B-4676

SUBJECT: Request for Mailing Labels only for TIP No. B-4676; WBS No. 33831.1.1, Replace Bridge No. 29 on SR 1101 (Oakwoods Road) over Cub Creek in Wilkes County, Division 11.

REPLACEMENT OF BRIDGE NO. 29 ON OAKWOODS ROAD OVER CUB CREEK IN WILKES COUNTY

TIP PROJECT No. B-4676

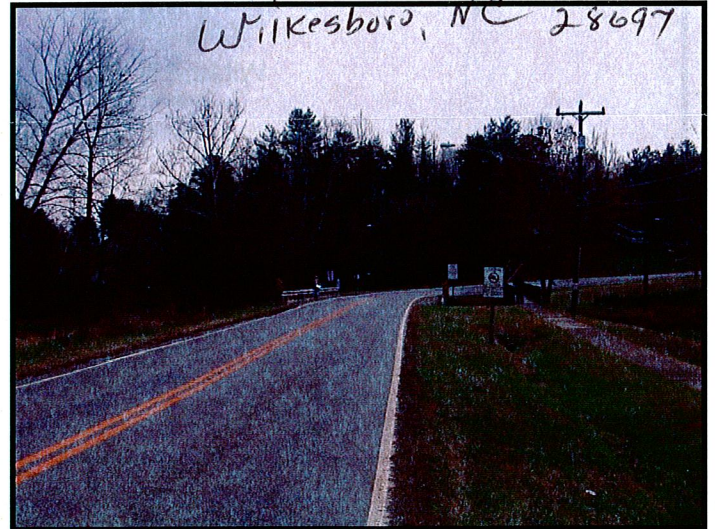
We endorse this proposed study. Thanks!!
